VILLAGE OF ROYAL PALM BEACH, FLORIDA

PROJECT NAME: COMMONS PARK PATHWAY LIGHTING  
PROJECT NUMBER: PR1903

**ADDENDUM NUMBER: FIVE**

DATE OF ISSUANCE: September 28, 2021

DATE: AUGUST 2021  
SHEET: E-11 OF 25

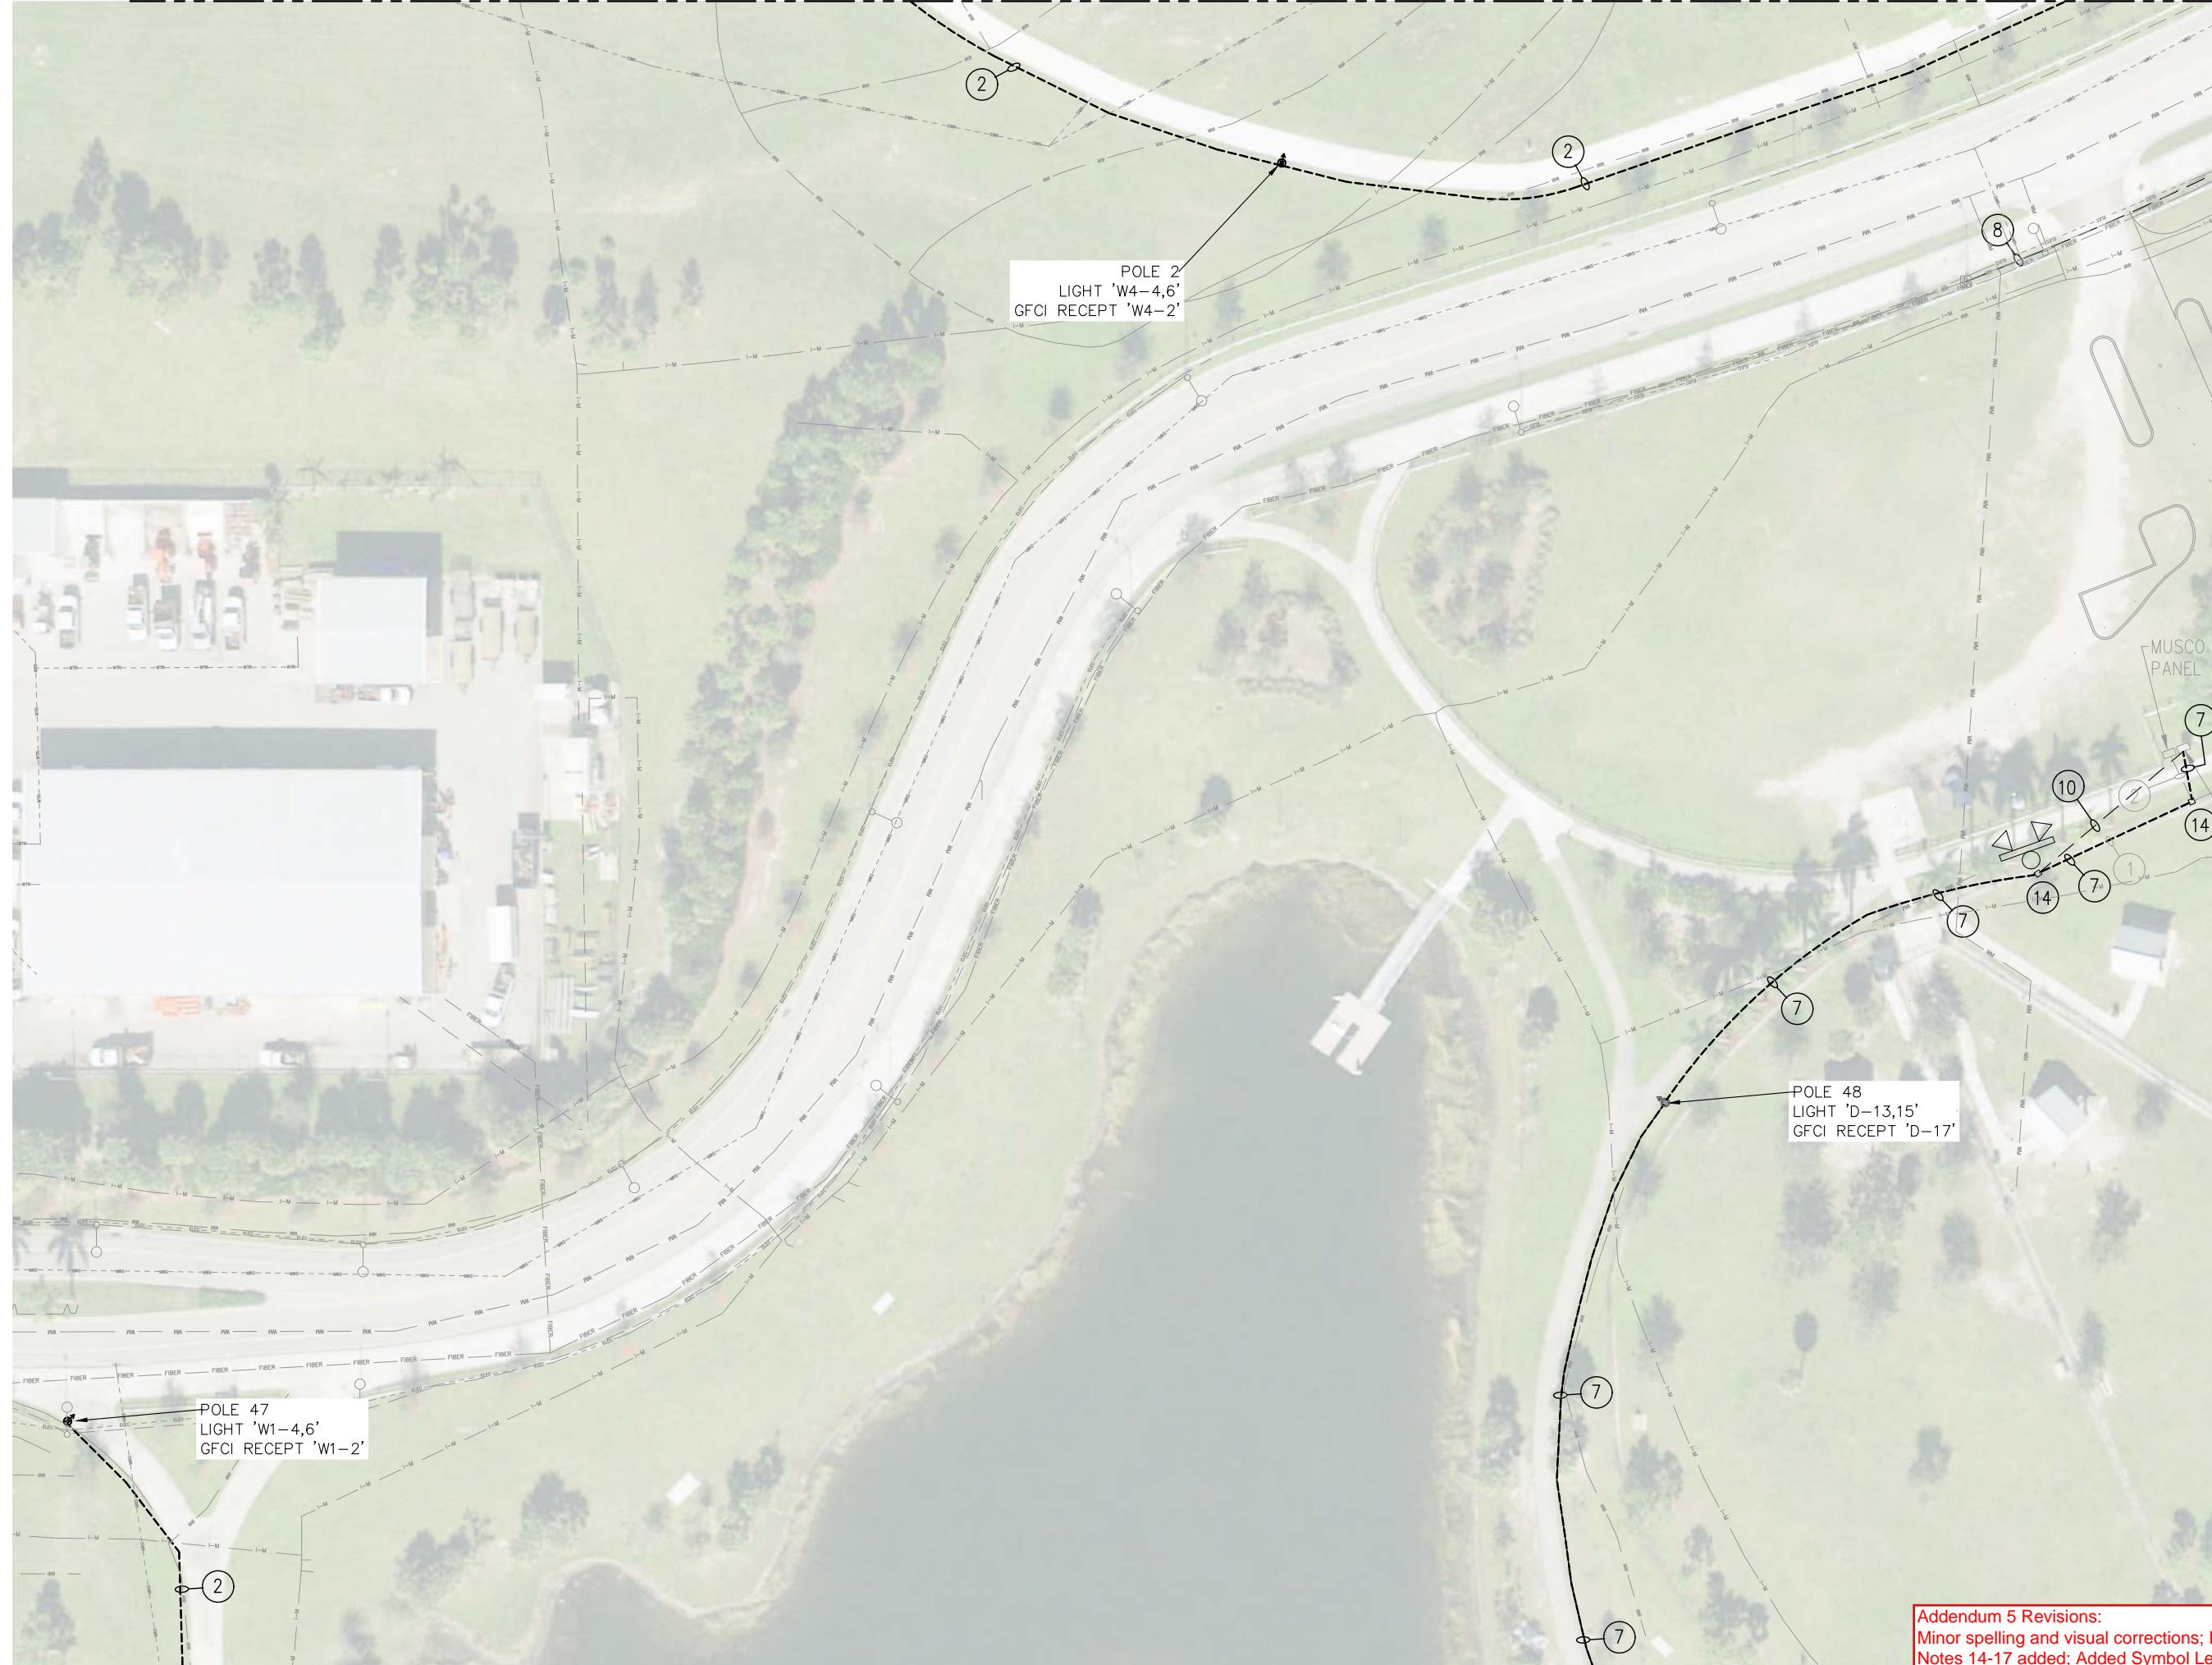
Addendum 5 Revisions:  
Minor spelling and visual corrections; Key Note 5 updated; Key Notes 14-17 added; Added Symbol Legend; Intermediate pull boxes in the middle of each run between proposed poles have been removed.  
Clarified configuration of conduits near existing sports lighting pole

DESIGNED BY: SPH  
DRAWN BY: SPH  
REVIEWED BY: LMS  
DATE: AUGUST 2021  
SHEET: E-16 OF 25

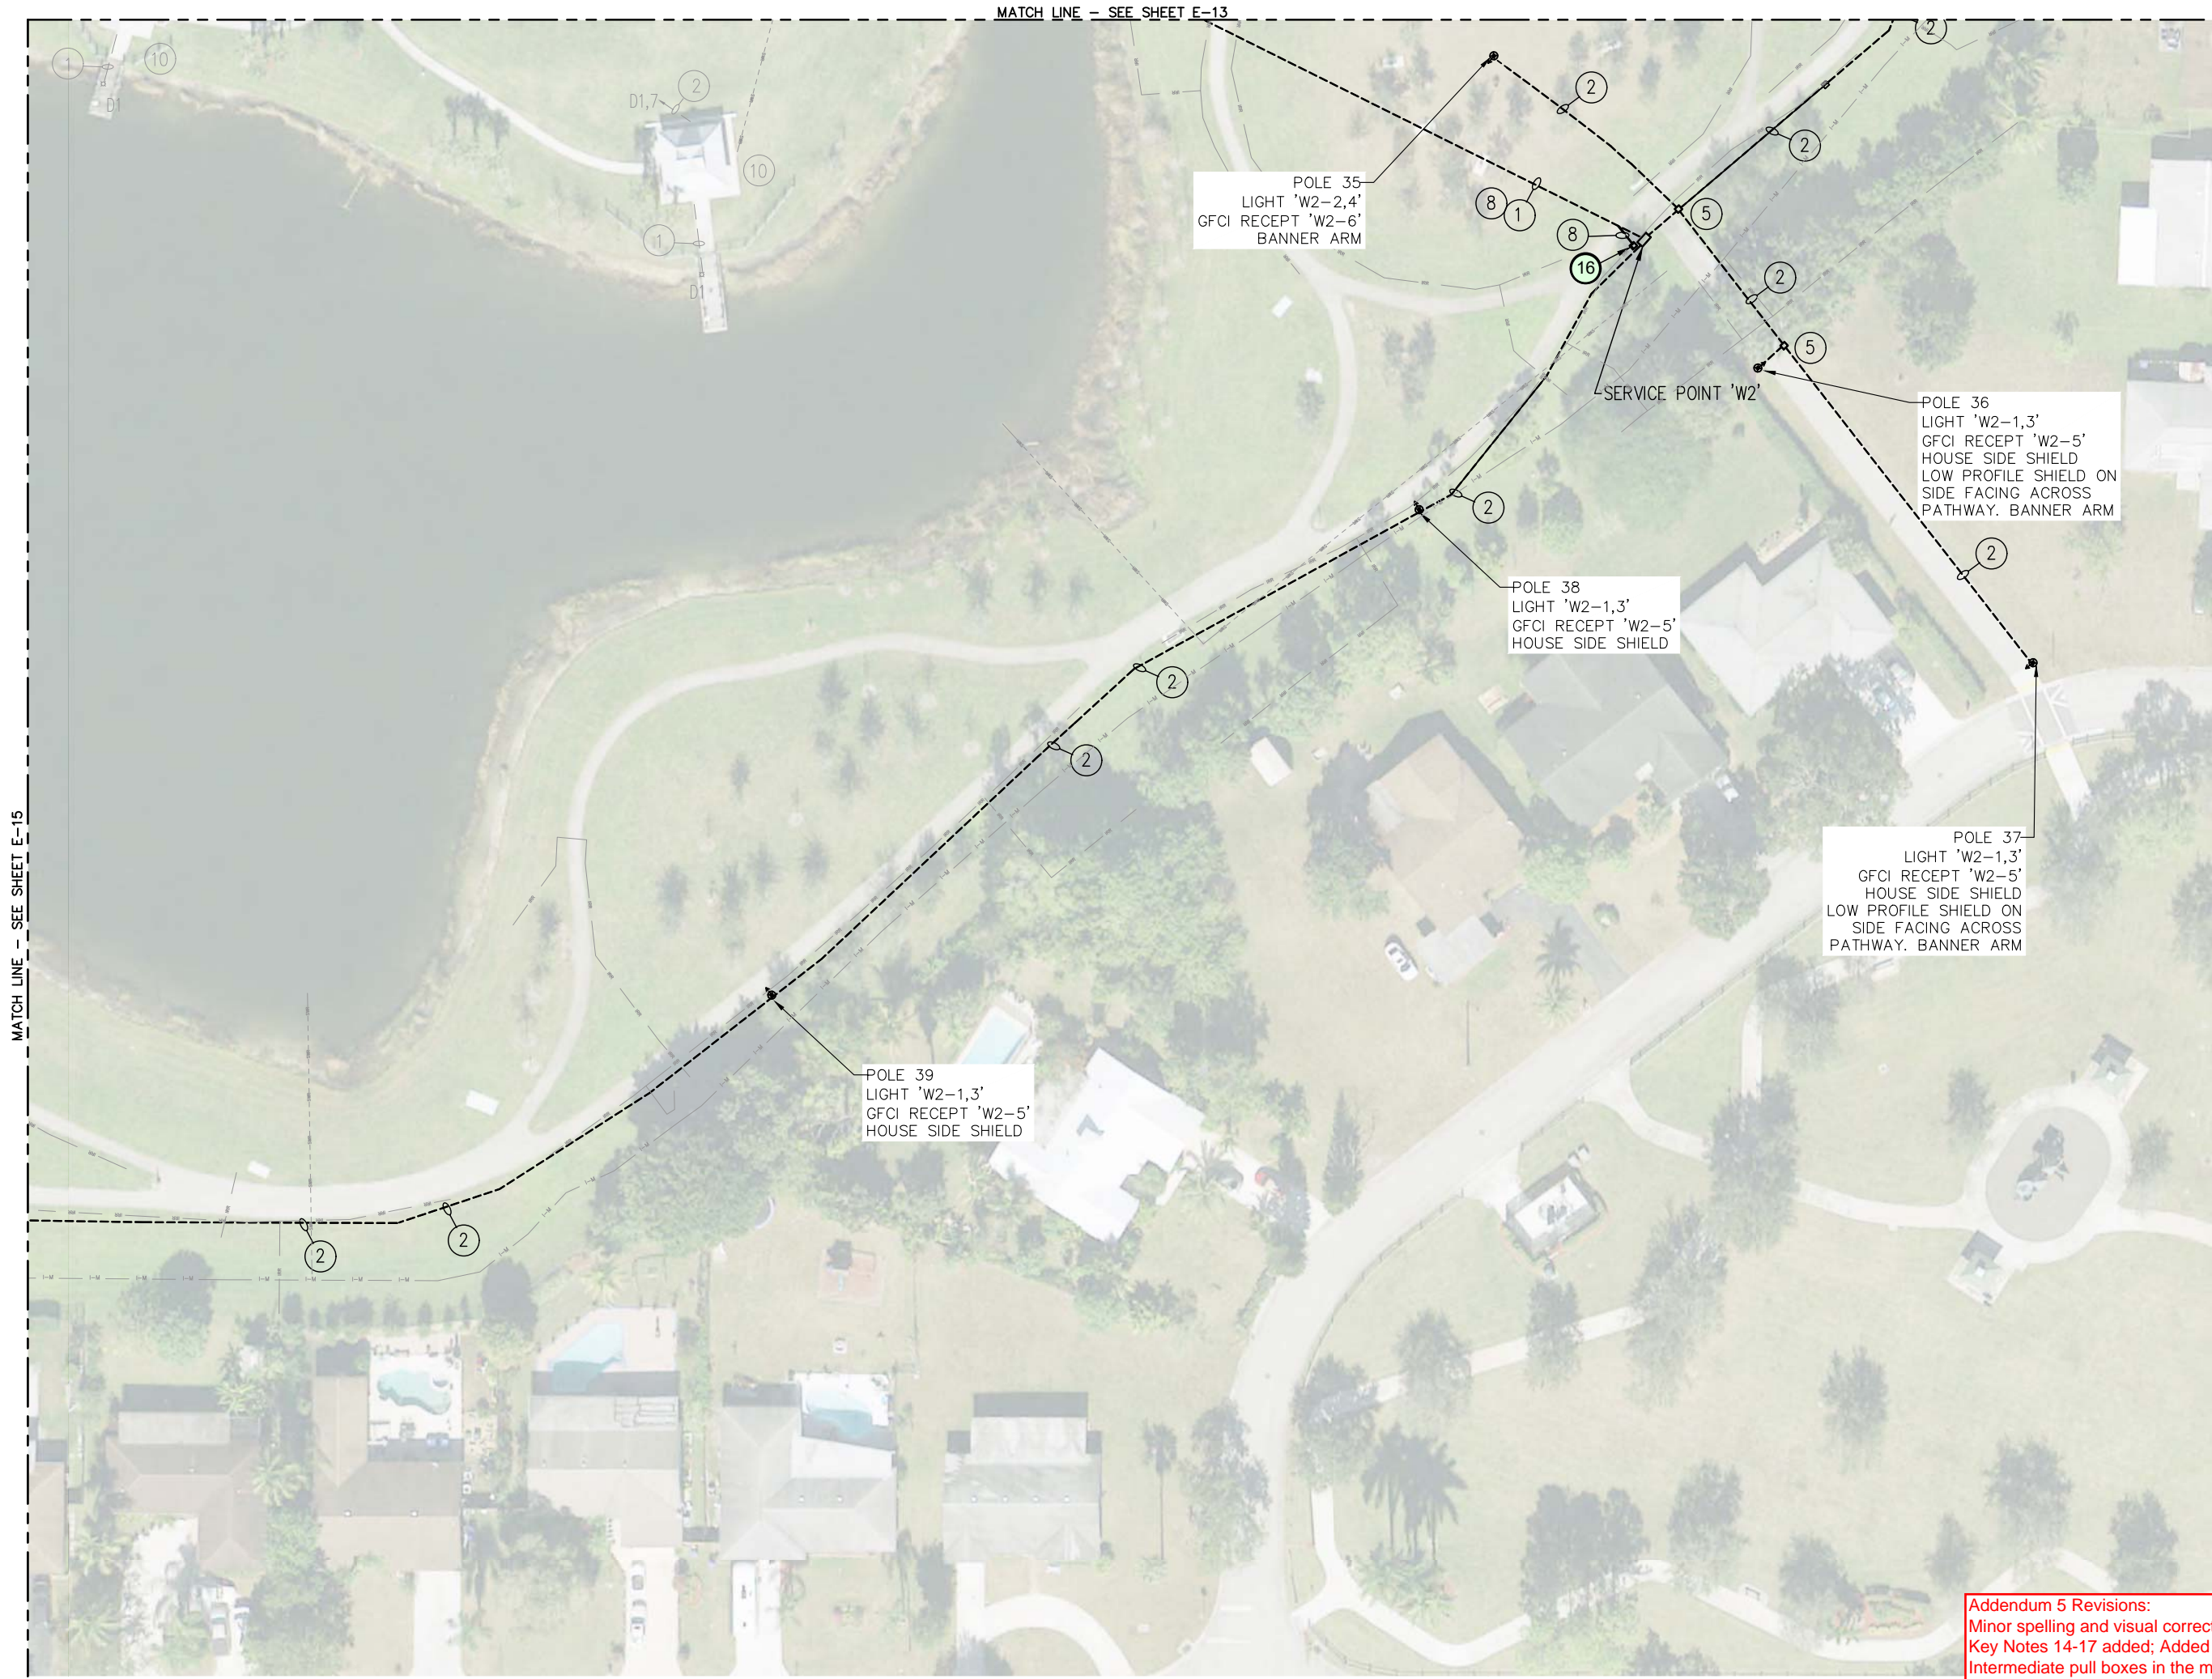
Addendum 5 Revisions:  
Minor spelling and visual corrections; Key Note 5 updated;  
Key Notes 14-17 added; Added Symbol Legend;  
Intermediate pull boxes in the middle of each run between proposed poles have been removed.  
Added pull box for future use fiber conduit to terminate in.

DATE: AUGUST 2021  
SHEET: E-17 OF 25

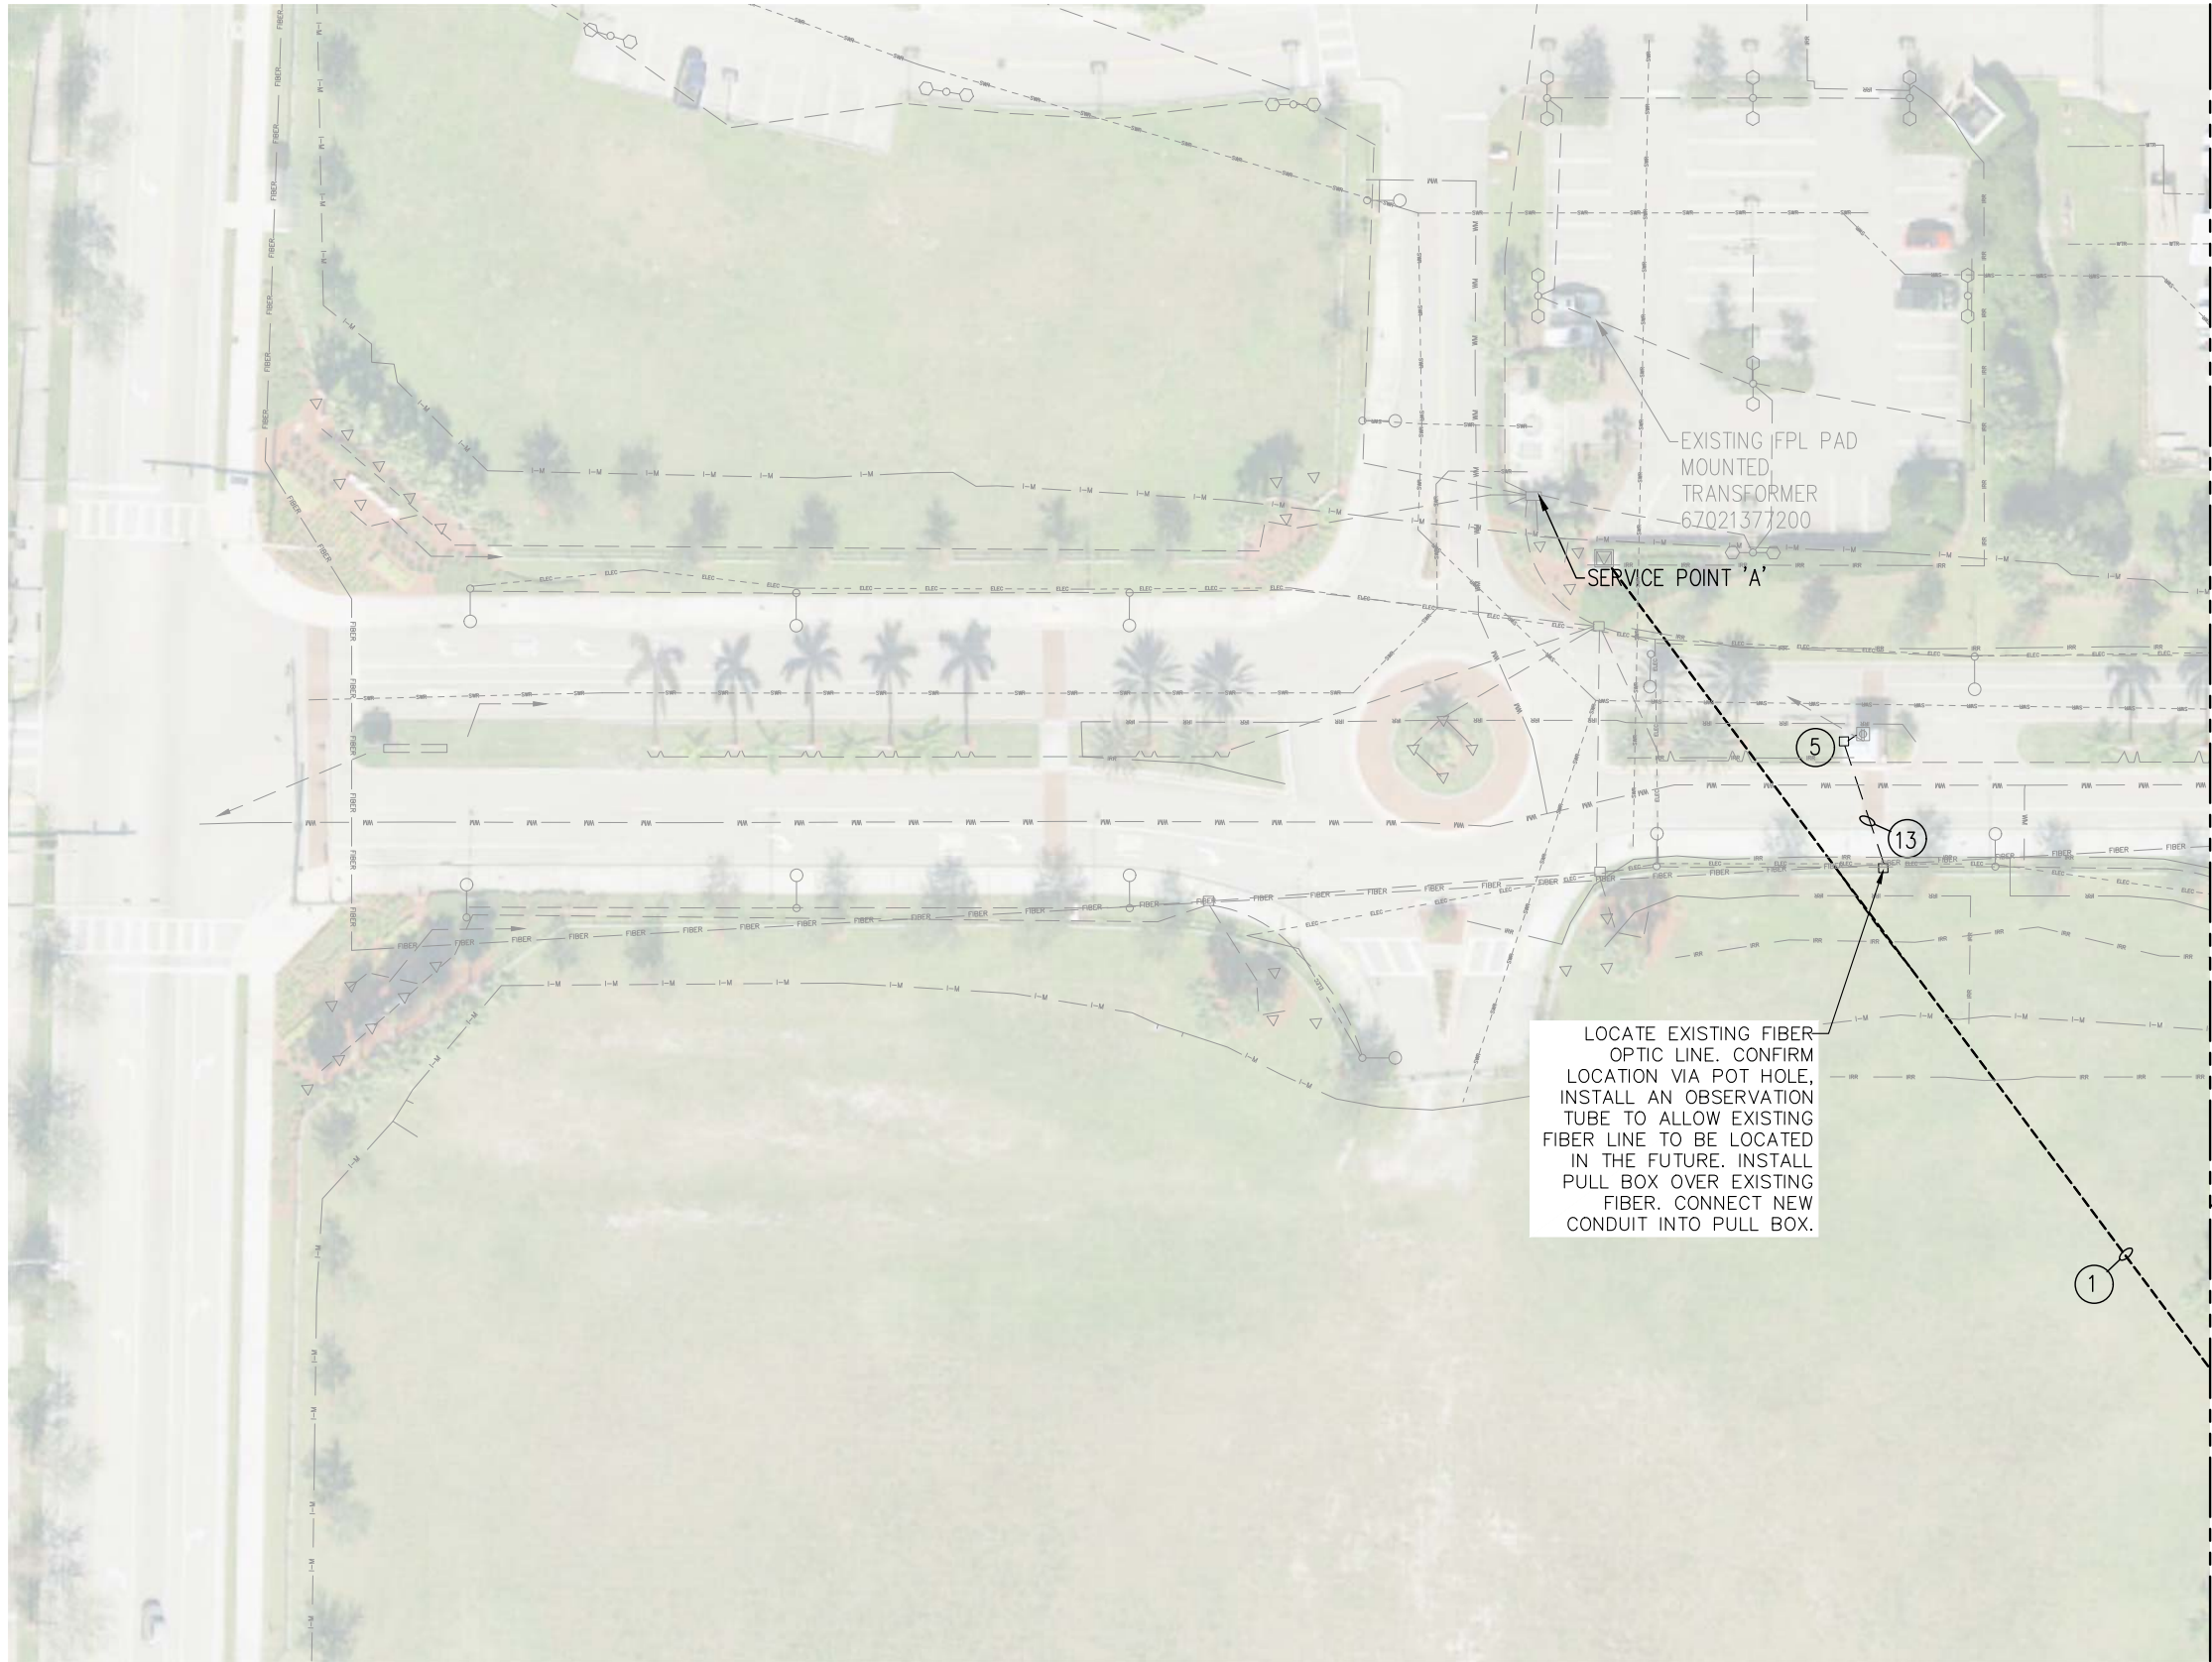
Addendum 5 Revisions:  
Minor spelling and visual corrections; Key Note 5 updated;  
Key Notes 14-17 added; Added Symbol Legend;  
Intermediate pull boxes in the middle of each run between proposed poles have been removed.  
Revised call-out for proposed fiber pull box.
